**Fox Metro Water Reclamation District  
Boulder Hill Subdivision – Sanitary Sewer Replacement and Spot Repairs**

**ADDENDUM NO.2**

March 15, 2024

**SUMMARY OF QUANTITIES AND SYMBOL LEGENDS**

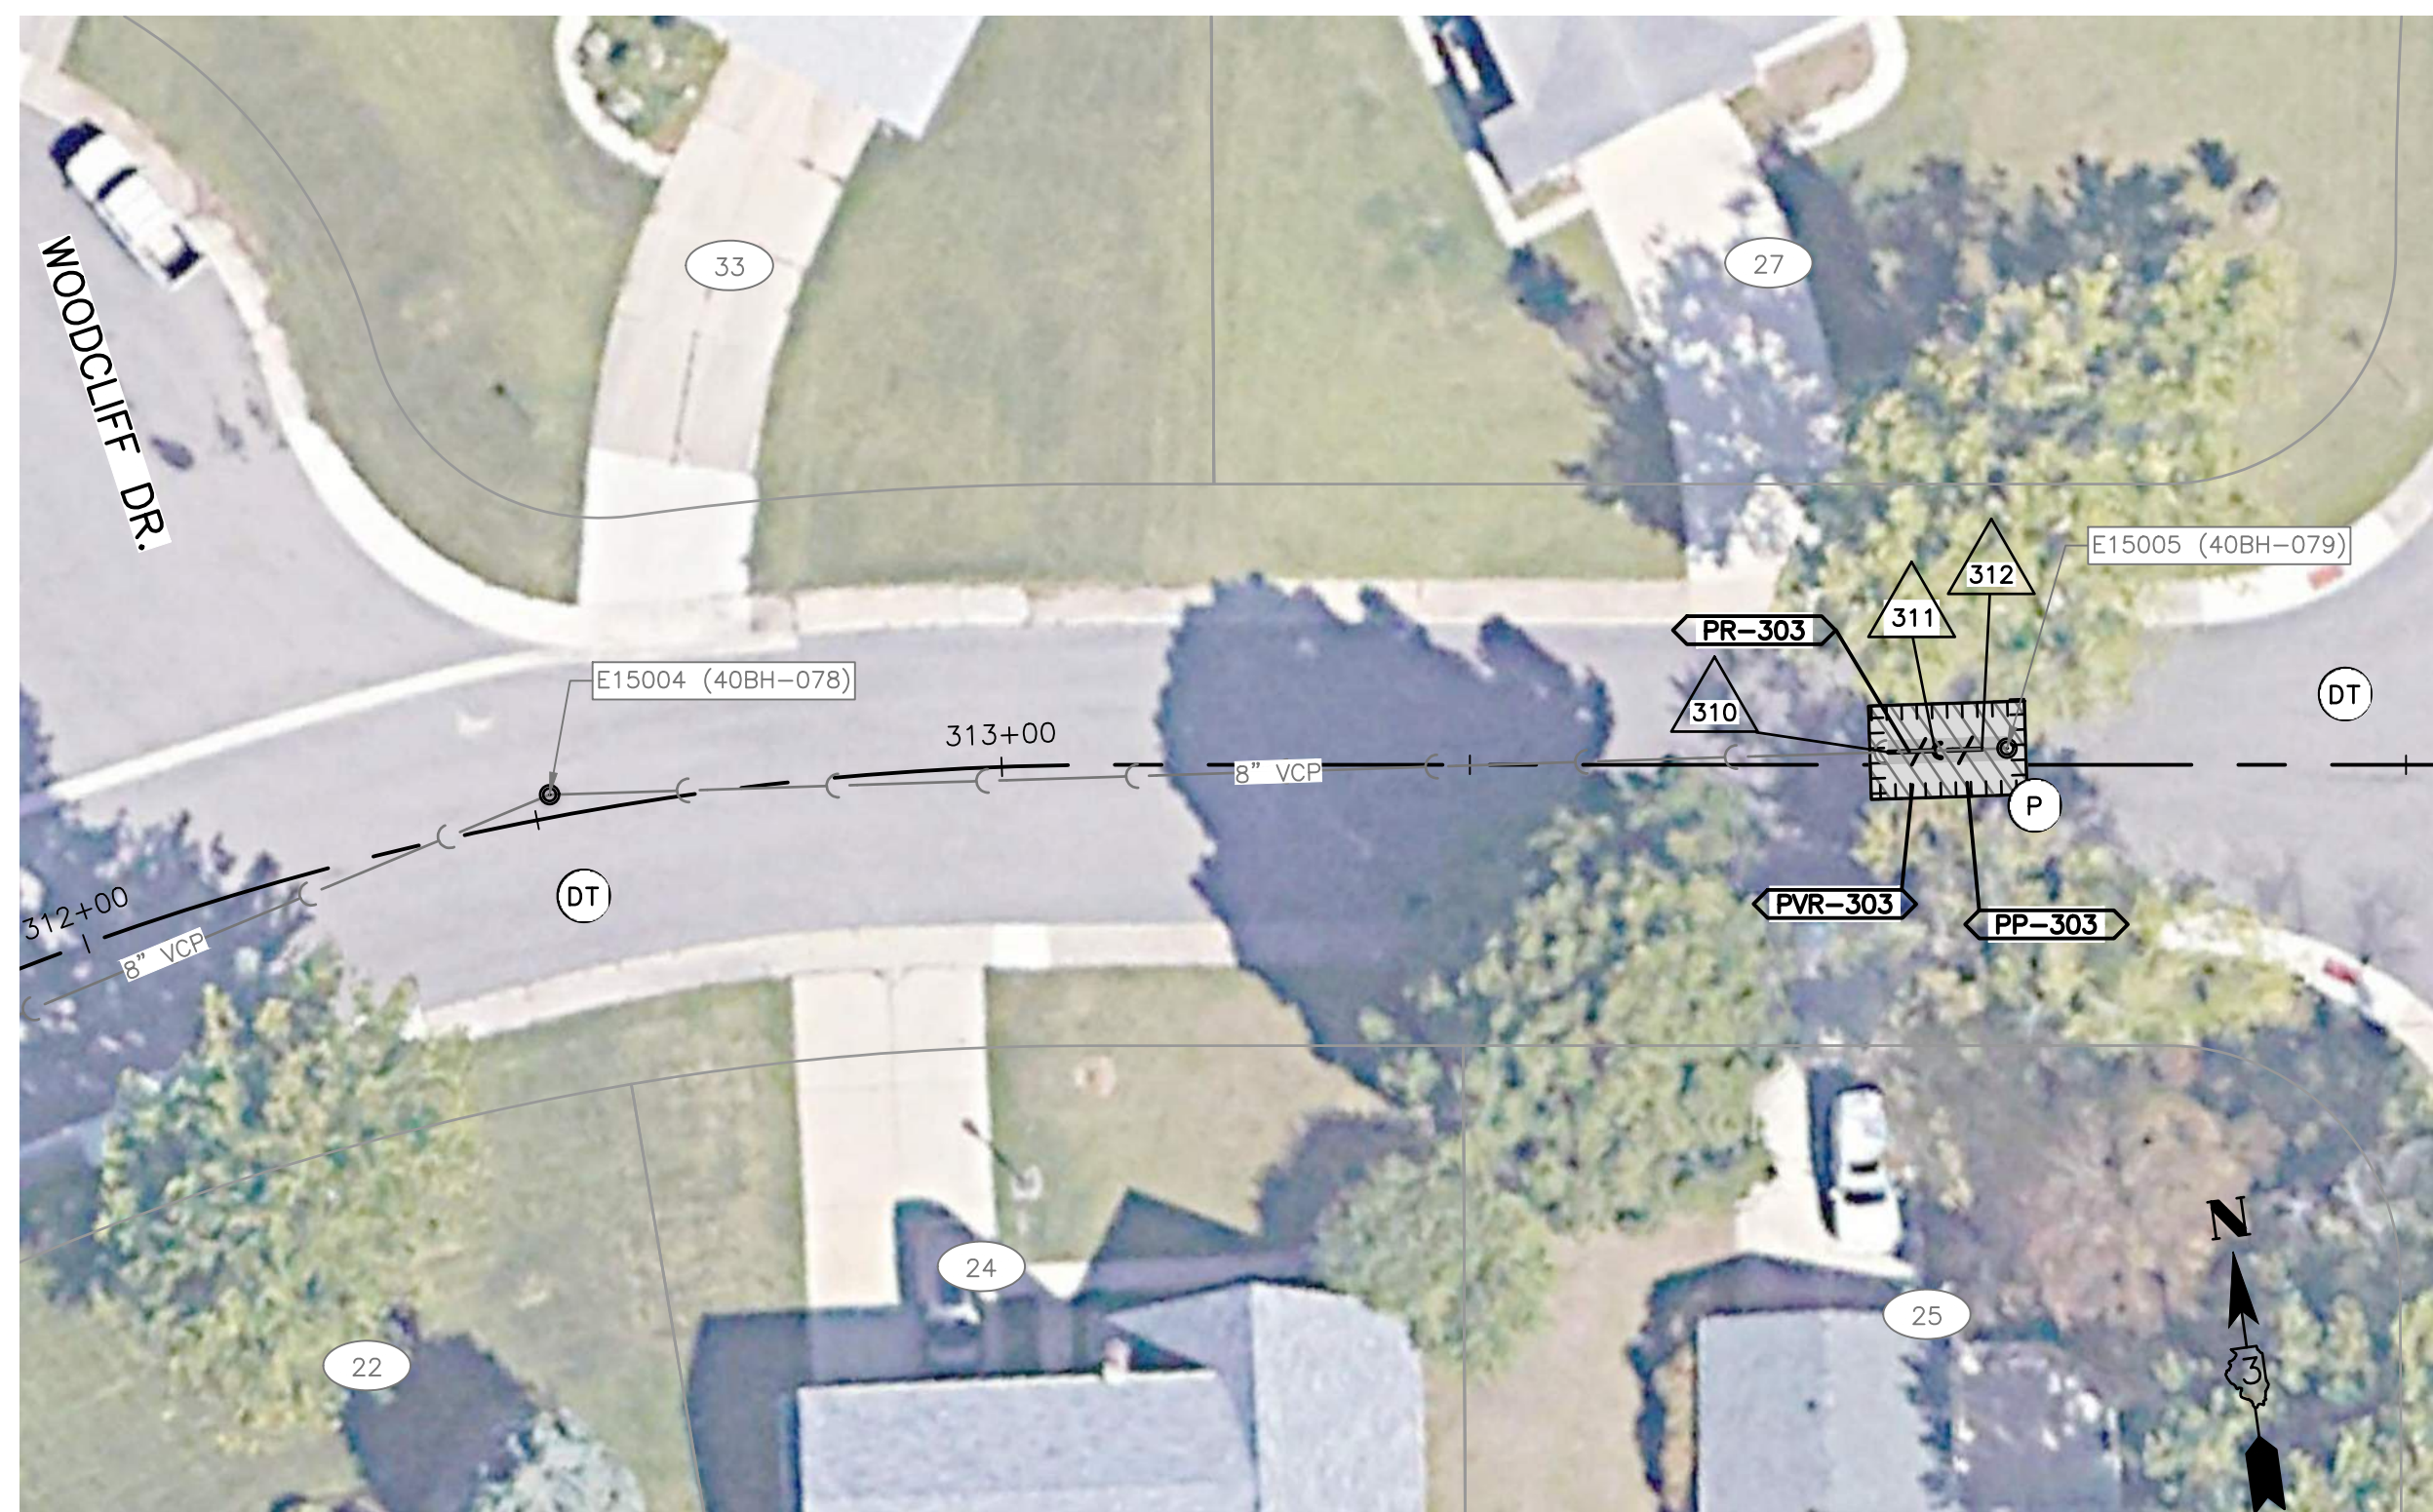
- b. See Sheet 03: Schedule of Quantities and Symbol Legends:
  - a. Include revised date per Addendum No. 2.
  - b. Revised bid item 2.01, 2.02, 2.04, 5.12, and 5.01.
  - c. Removed bid item 5.19 and 5.20 (Omitted) per Addendum No. 2.

- Sheet 01: Cover Sheet:
  - Include revised date per Addendum No 2.
- Sheet 03: Schedule of Quantities and Symbol Legends:
  - Include revised date per Addendum No 2.
  - Revised Summary of Quantities as shown.
  - Removed Pay Items as shown on the sheet and BLR 12201 (Schedule of Prices)
- Sheet 04: Schedule of Quantities:
  - Include revised date per Addendum No 2.
  - Revised Schedule of Quantities tables as shown.
- Sheet 23: Woodcliff Dr. / Knollwood Dr.:
  - Revisions per Addendum No 2.
  - Revised Pipe Removals as shown in tables.

**KNOLLWOOD DR.**

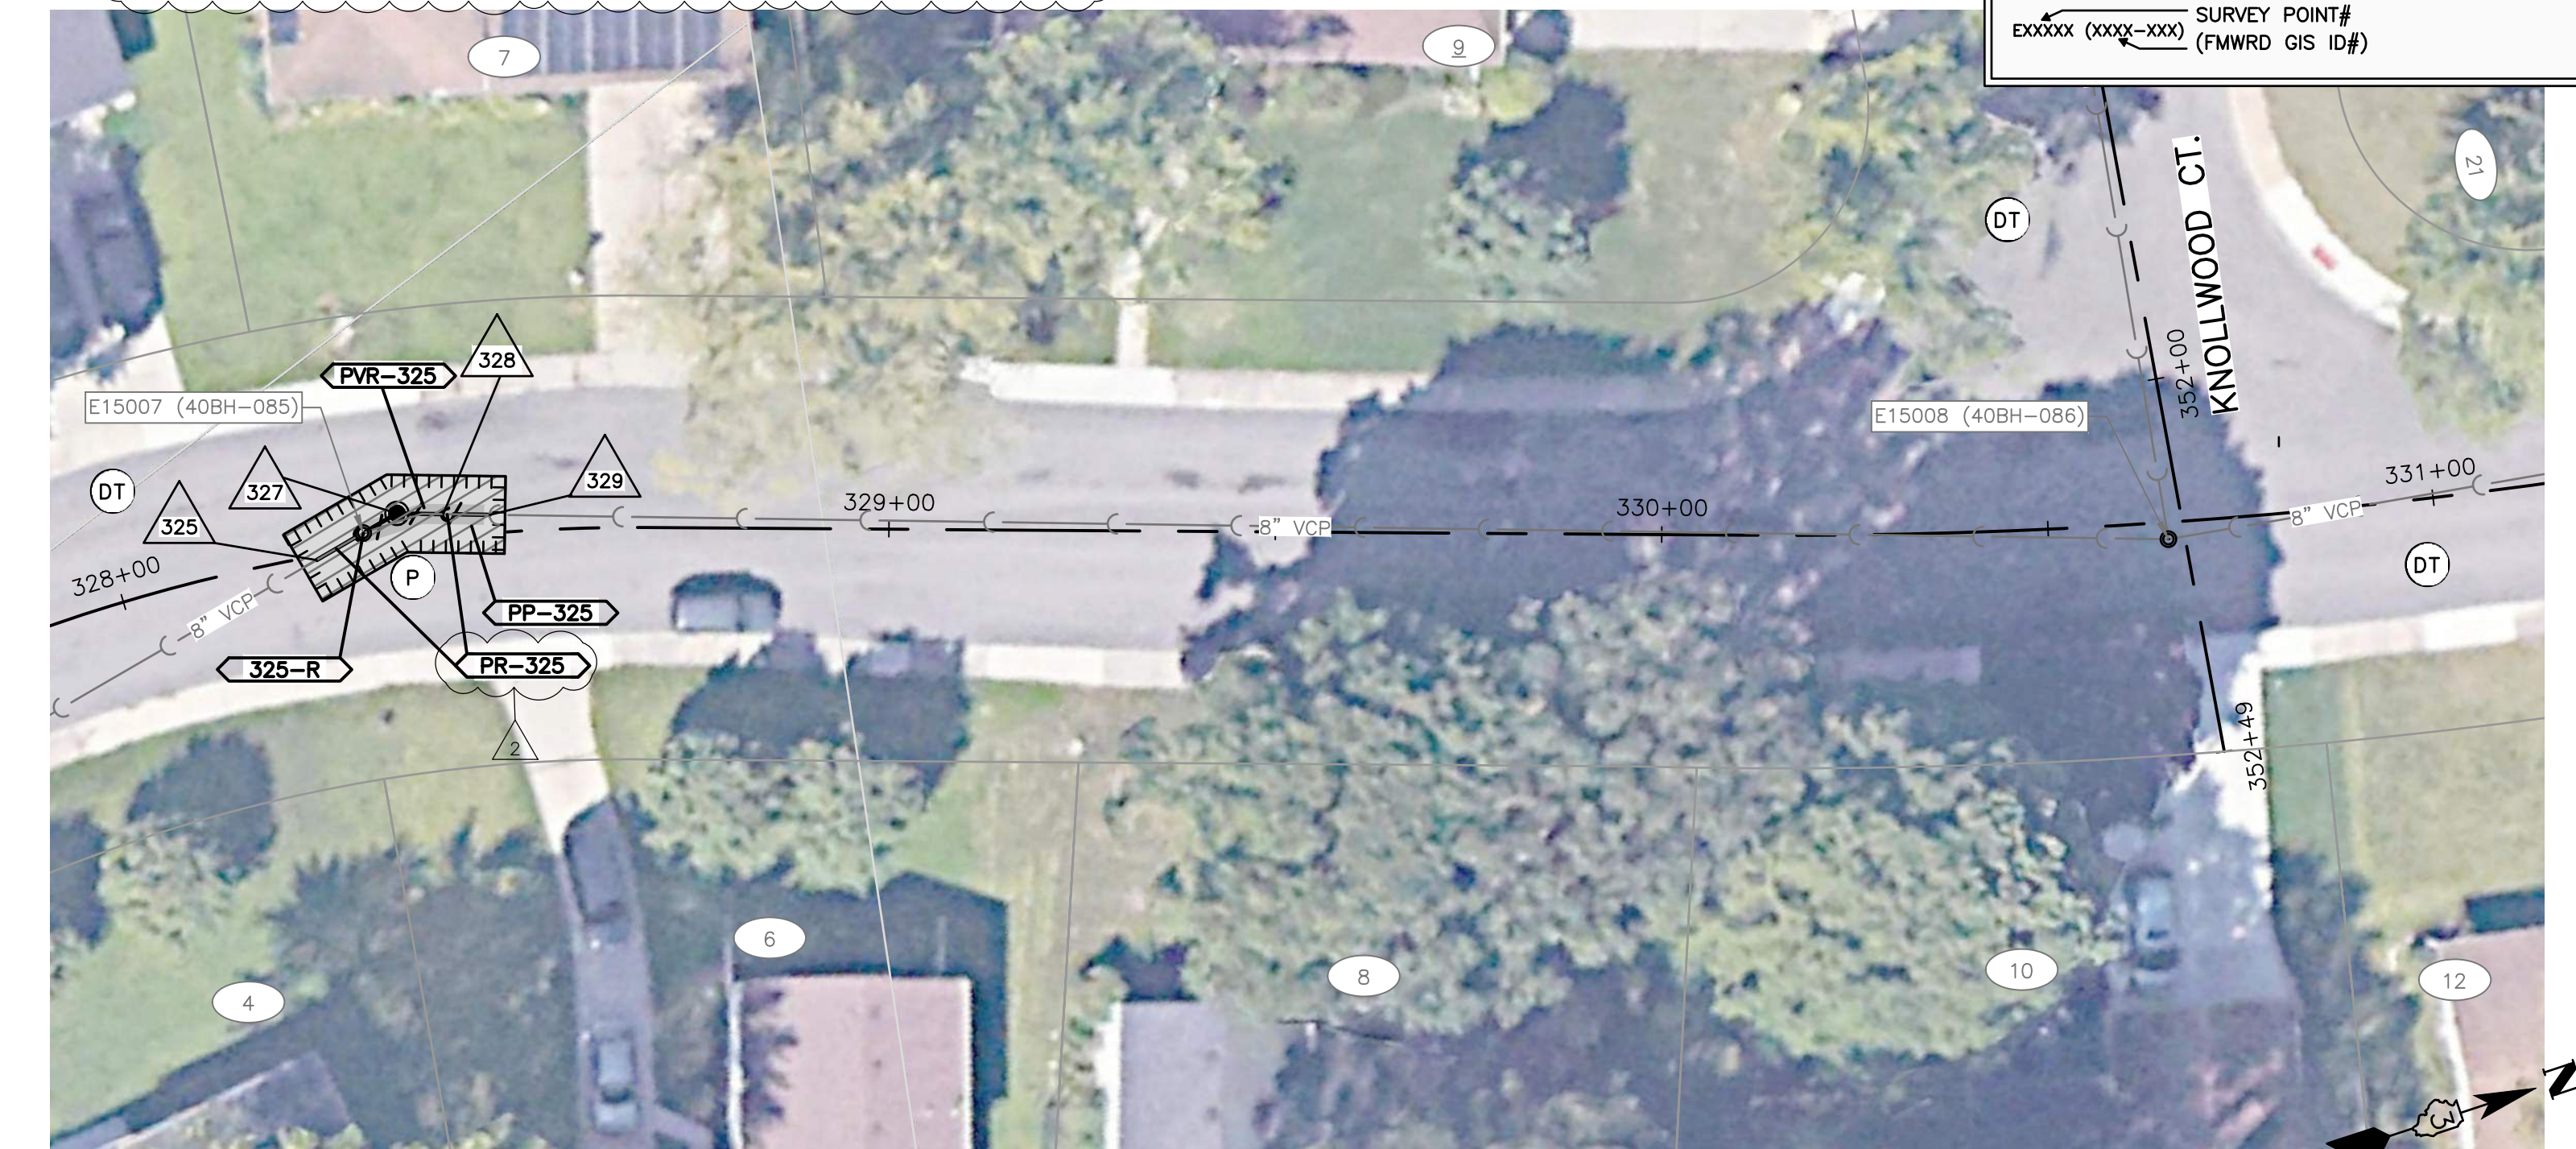
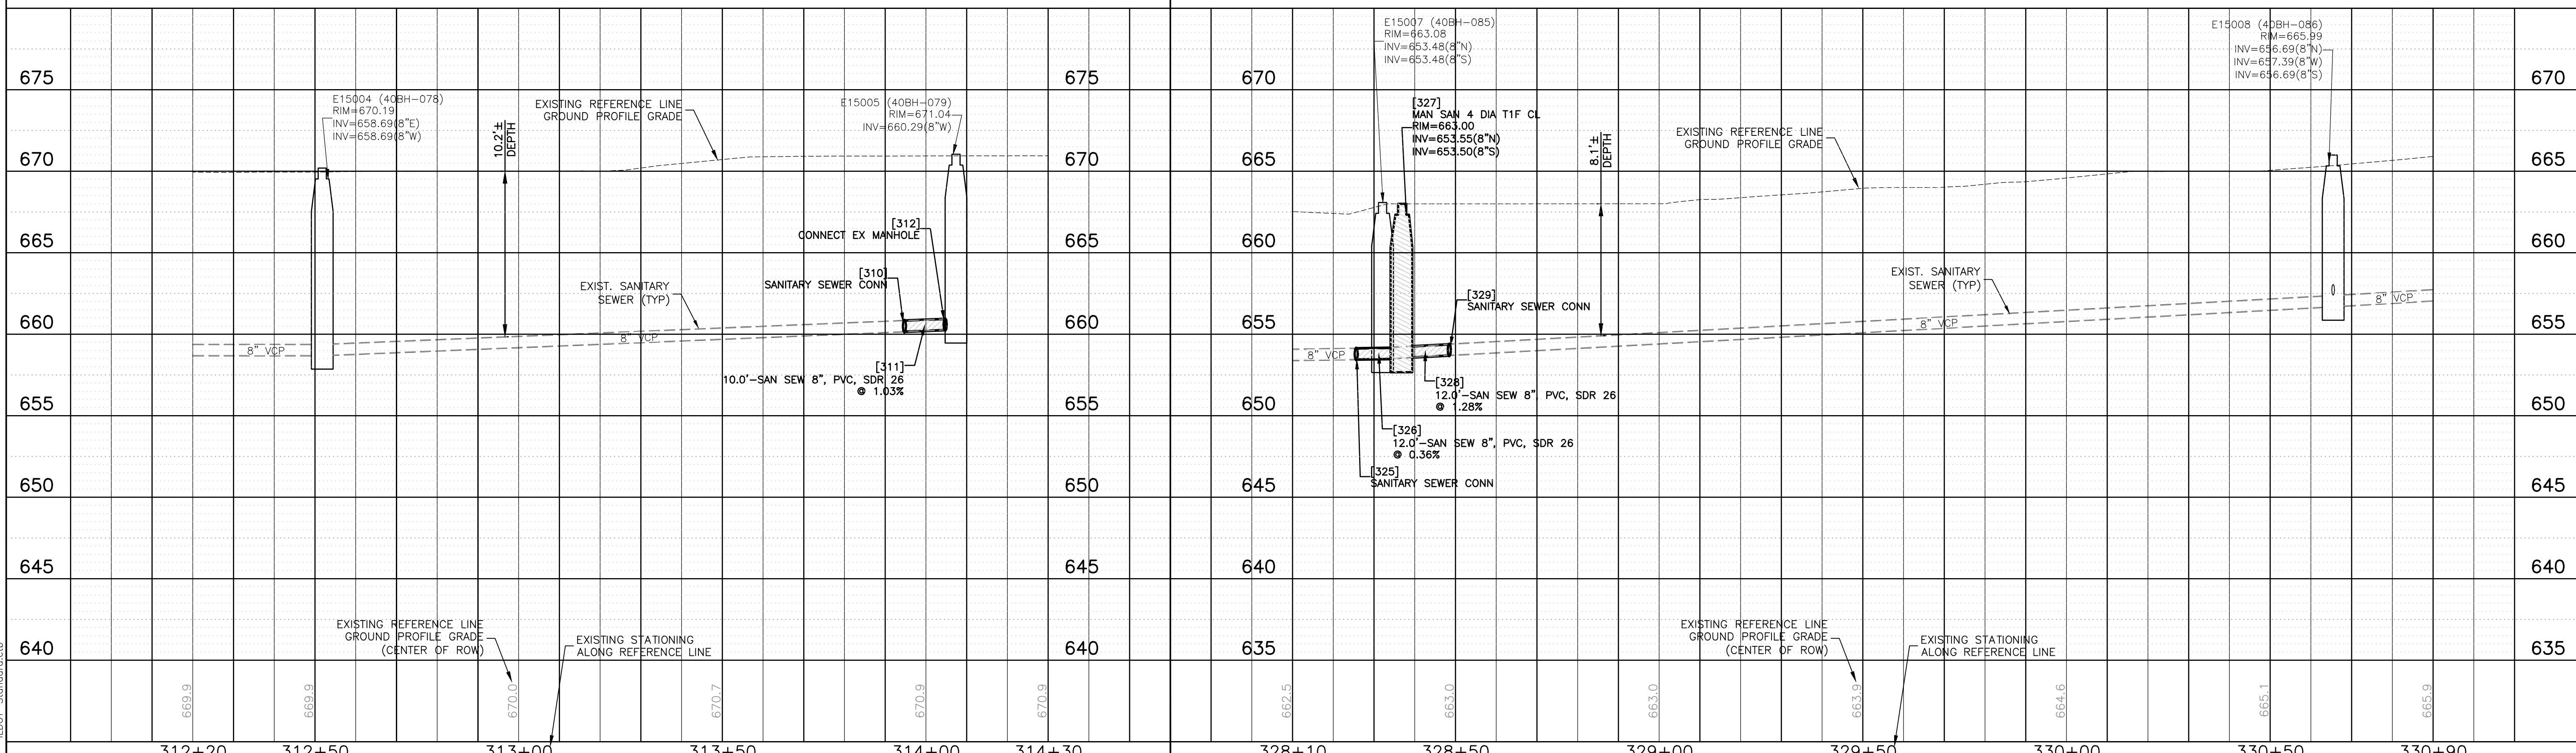
Question 12: No Sanitary pipe removal called out at 325-R on plan sheet 23.

**Response: Plans have been revised accordingly, see sheet 23 and bid item 5.12 for plan quantity revisions.**
